From: [Erin L. Proulx](#)
To: [Planning - Info - Shr](#); planning@portsmouthnh.gov; [Planning - Info - Shr](#); [Peter M. Stith](#); [Rick Chellman](#)
Cc: [Ryan Proulx](#)
Subject: 134 Pleasant Street (LU-25-138) — Abutter Comments in Response to Staff Memo
Date: Tuesday, March 24, 2026 3:54:27 PM

Re: Objection to Subdivision and Site Plan Review Application, 86 Farm Lane (Map 236, Lot 74), LU-26-16, Hearing of May 21, 2026

Public Comment on Planning Board Site Plan Review Item “D” 94 Langdon Street/98 Cornwall Street

Proposed bioretention ponds, paved roadway extension, and stormwater discharge point shown relative to the 100-foot wetland buffer

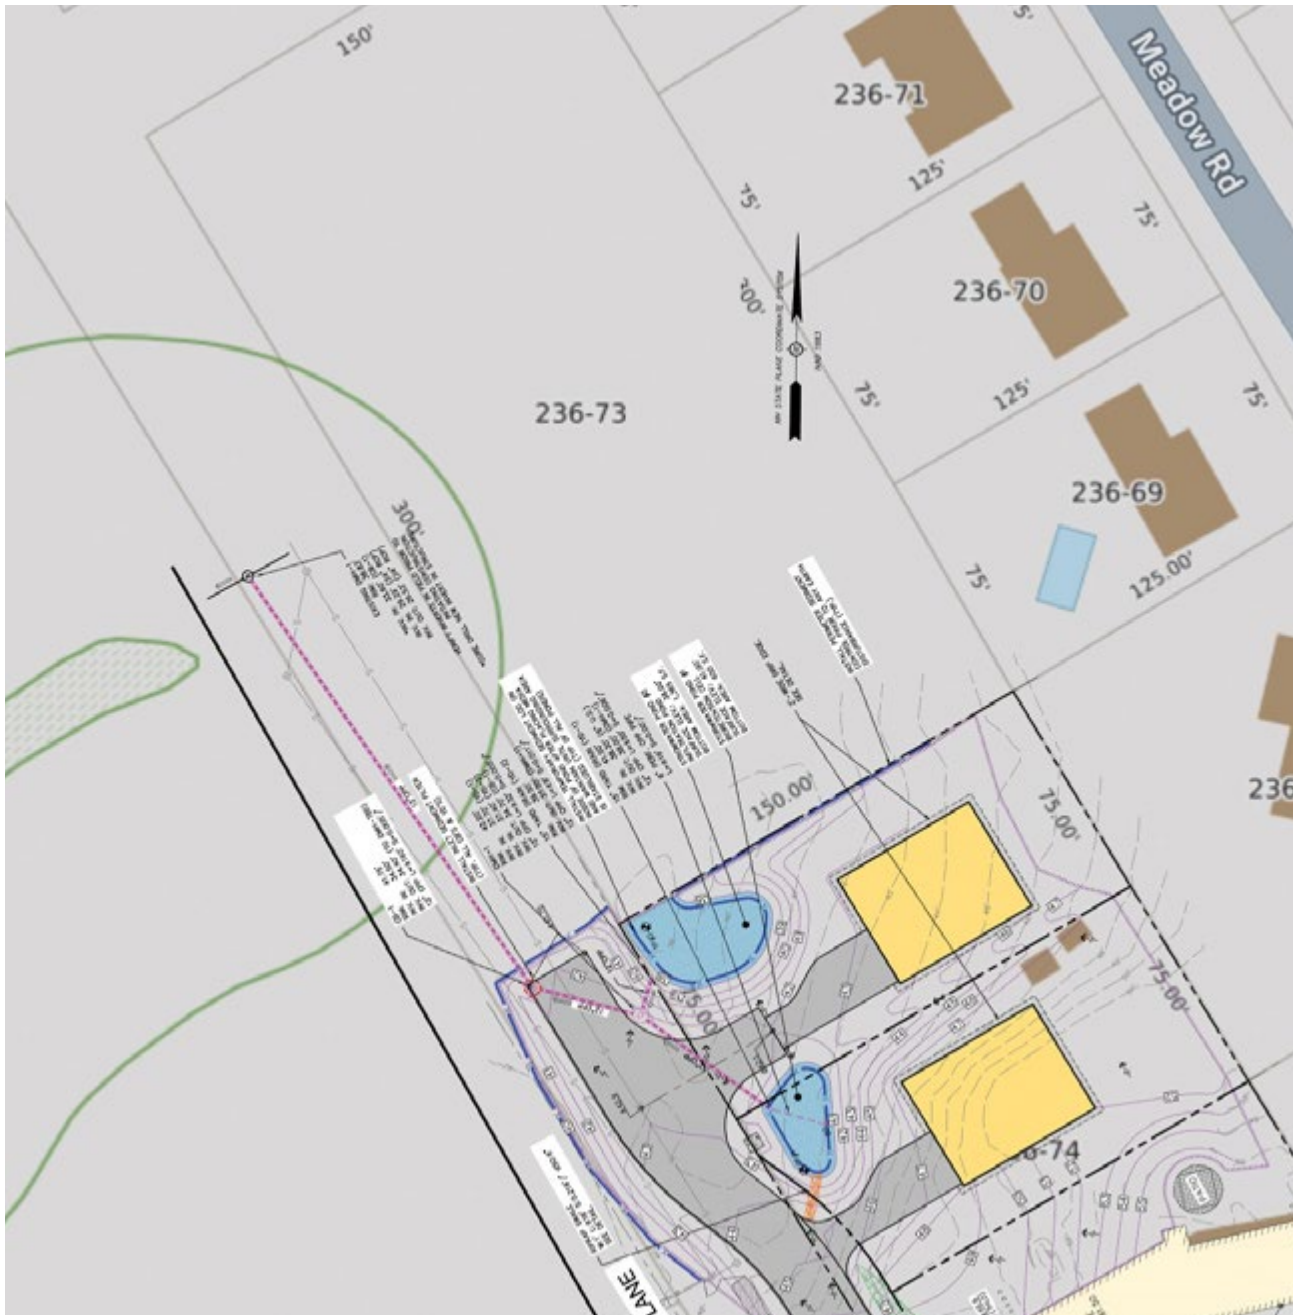
The applicant's plans state, on Sheet C-1, "WETLAND BUFFER: NONE (WETLAND LESS THAN 10,000 S.F.)" and, on Sheet C-2, "NO WETLANDS WERE IDENTIFIED WITHIN THE LIMITS OF THE PROJECT AREA, BASED ON THE CITY OF PORTSMOUTH GIS." The applicant's March 2026 Green Statement similarly claims the project does not impact wetlands or wetland buffer.

The infrastructure improvements the applicant proposes to install, including sewer connections and stormwater drainage features shown on Sheet C-6, extend well beyond the lot boundaries into the Longmeadow Lane right-of-way. Several of these proposed improvements appear, based on overlay with PortsmouthMaps, to fall within the 100-foot wetland buffer. At least one stormwater drainage feature appears to fall within the wetland itself. Each of these improvements involves ground disturbance, excavation, and permanent below-grade construction in a regulated area. Under Section 10.1017, this work requires a Wetland Conditional Use Permit, which has not been requested.

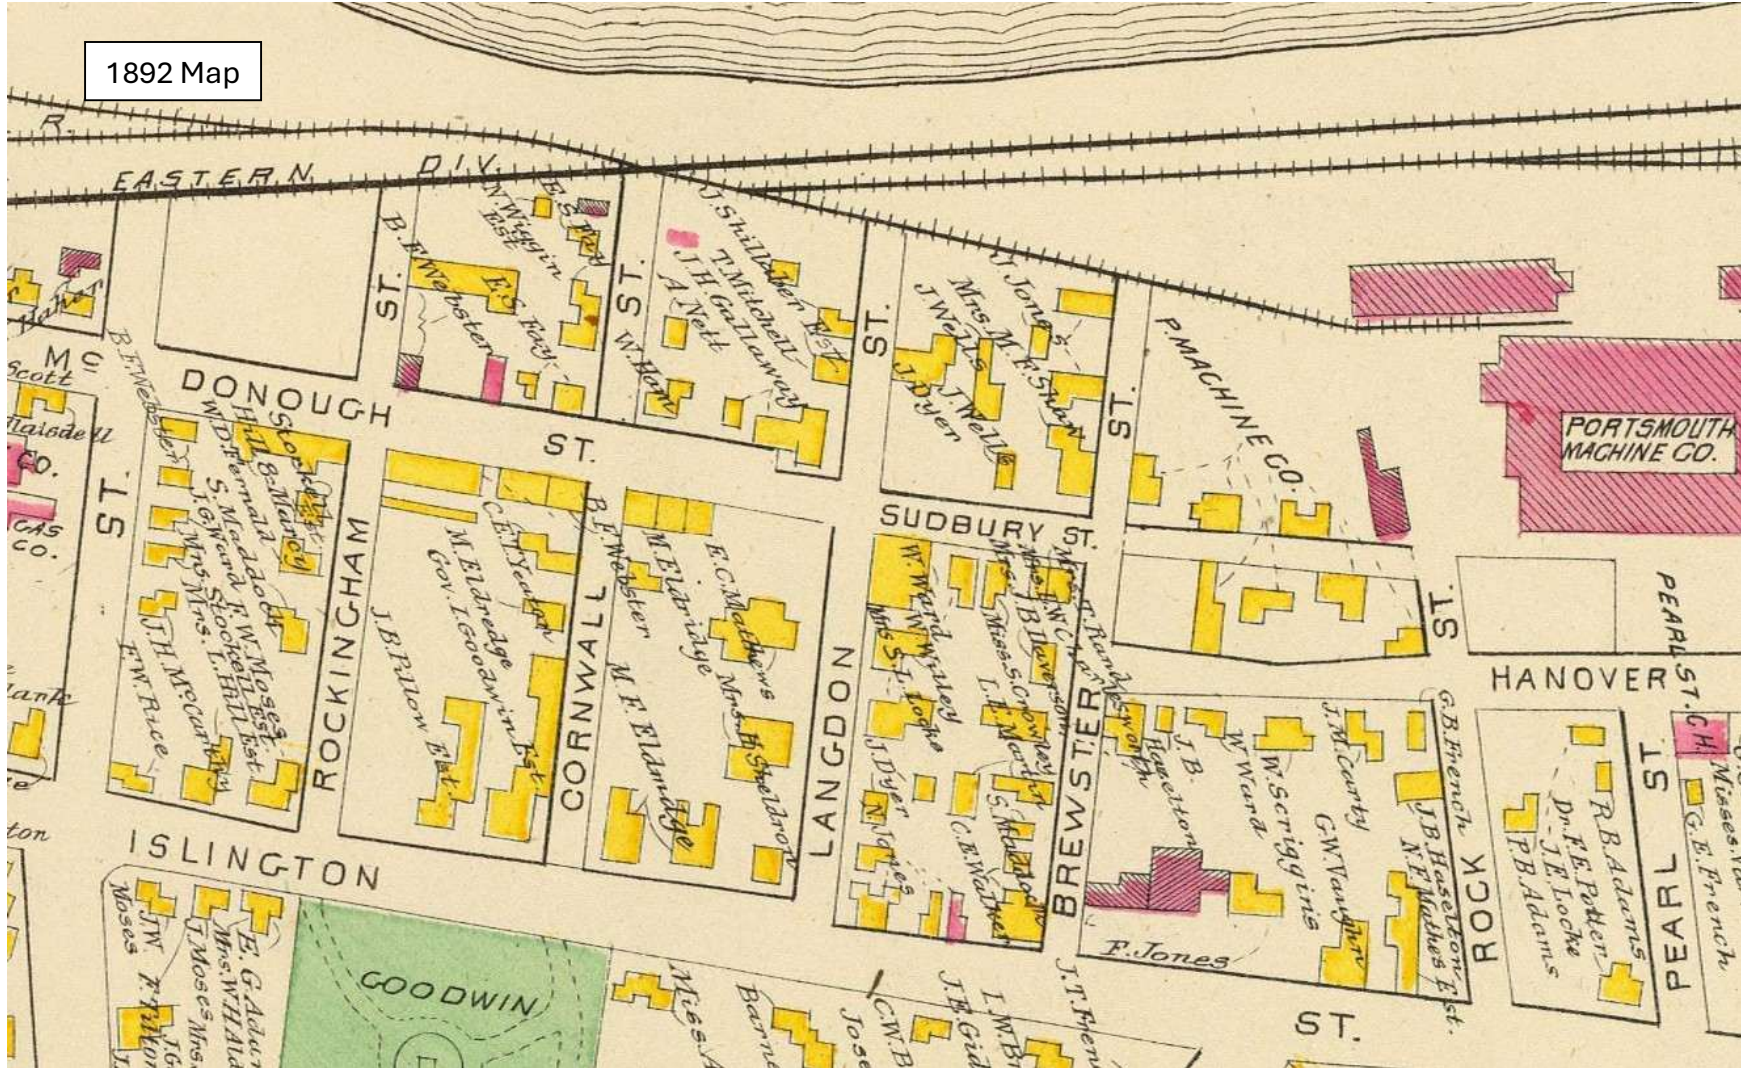
The apparent vehicle turnaround shown on the applicant’s site plan could be reconfigured to be an ingress from Cornwall Street along the 48 feet of frontage that Lot 139-1 has along the east side of the street. This would leave room at the end of Cornwall Street for snow accumulation due to street plowing in the winter.

Elimination of the common driveway leading to Langdon Street could allow for a home to be positioned parallel to the street with a driveway having two parking locations in front of a two-car garage, mirroring the current configuration of the homes at 81, 82, 91 and 101 Langdon Street. It should still be possible to include a walking path from Dwelling Unit 2 and Dwelling Unit 3 across Condominium-owned land adjacent to Dwelling Unit 1 to allow pedestrian access for those two units to Langdon Street, facilitating easy walking access to Rock Street Park.

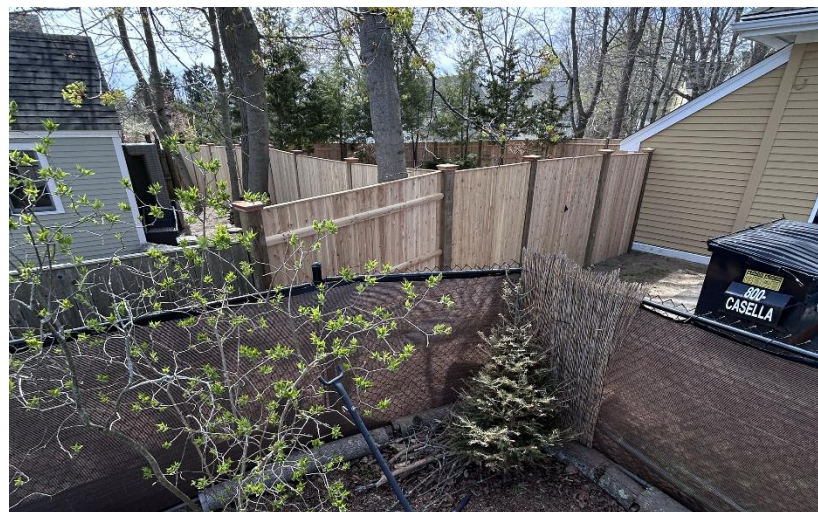
Following the April TAC meeting, the applicant removed their existing fence and installed a new fence. The alignment of this new fence differs from what previously existed. Additionally, a new fence was constructed immediately adjacent to the southern edge of my property. These changes are not reflected on the revised site plan.

This photo shows the applicant's newly constructed fence with an additional fence panel that is located outside their property's enclosure.

Proposed Fence along my Western Boundary

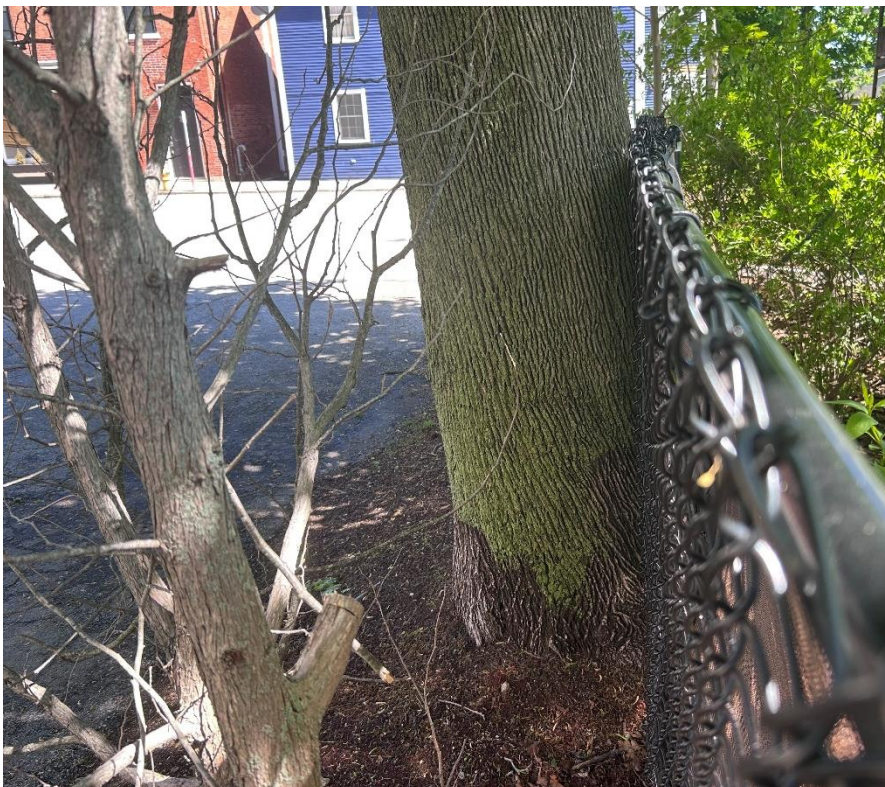
In the area between Tax Map 140, Lot 6 and Lot 7 where no new fence construction has yet occurred, the revised plans state: "Existing chain link to remain. New 6' tall wooden stockade fence to be installed in front of it." However, the plan depicts the proposed fence immediately adjacent to my chain link fence and potentially connecting to the existing wooden portion of my fence. The plans also show the proposed fence running between my fence and a mature tree, which is not physically possible without disturbing one or the other.

The applicant's site plan proposes their fence installed in between the mature maple tree and chain link fence shown in the photo. This is physically impossible under existing conditions.

Highlighted circles on applicant's site plan excerpt show stakes labeled as "metal fence posts"

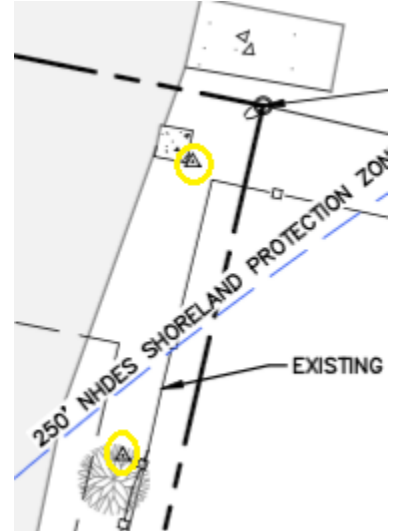
Additionally, the revised plans show the proposed fence in locations that appear to conflict with three existing metal posts/stakes located close to my fence line and appear in a straight line. Two of these posts are noted on the applicant's own survey and labeled as "metal fence post". These posts align with historical tree locations and correspond more closely to the deed measurements.

This photo shows two metal posts/stakes located near my fence line. These stakes correspond similarly with deed measurements.

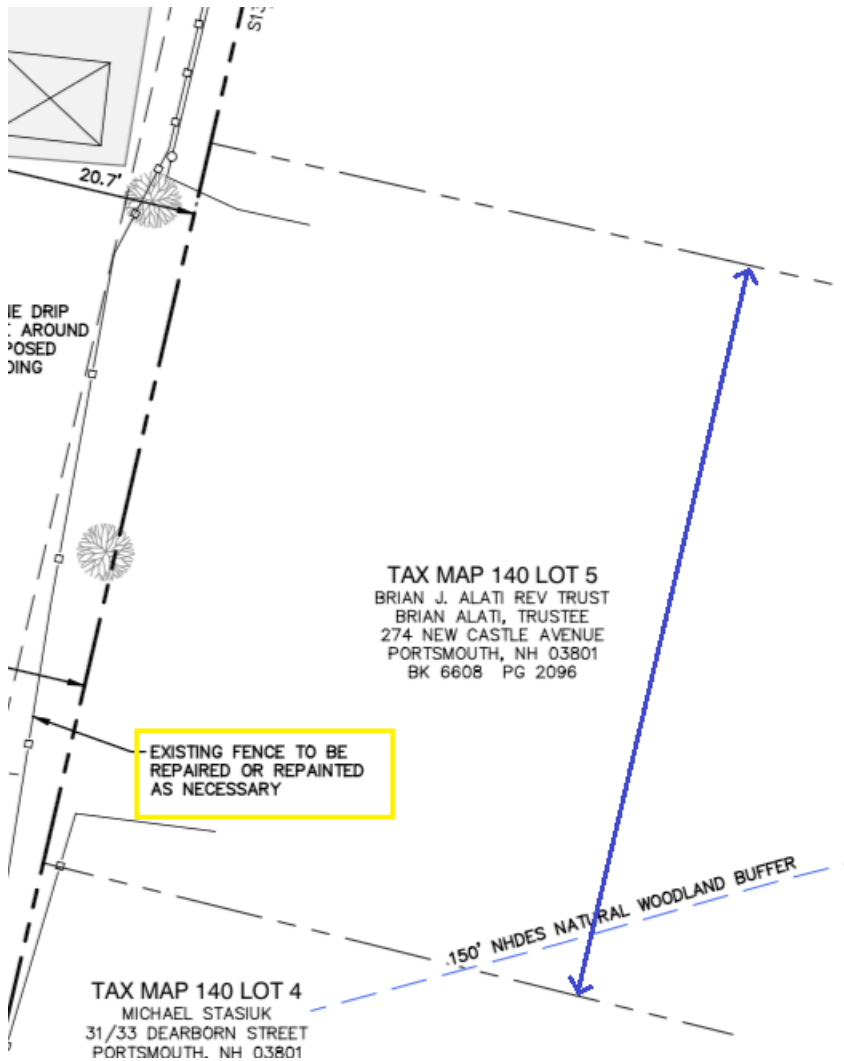
This site plan excerpt shows my wood fence labeled as "existing stockade fence". It also appears to show the applicant's proposed fence possibly connecting to this fence.

The applicant does not have consent to use my fence as their own.
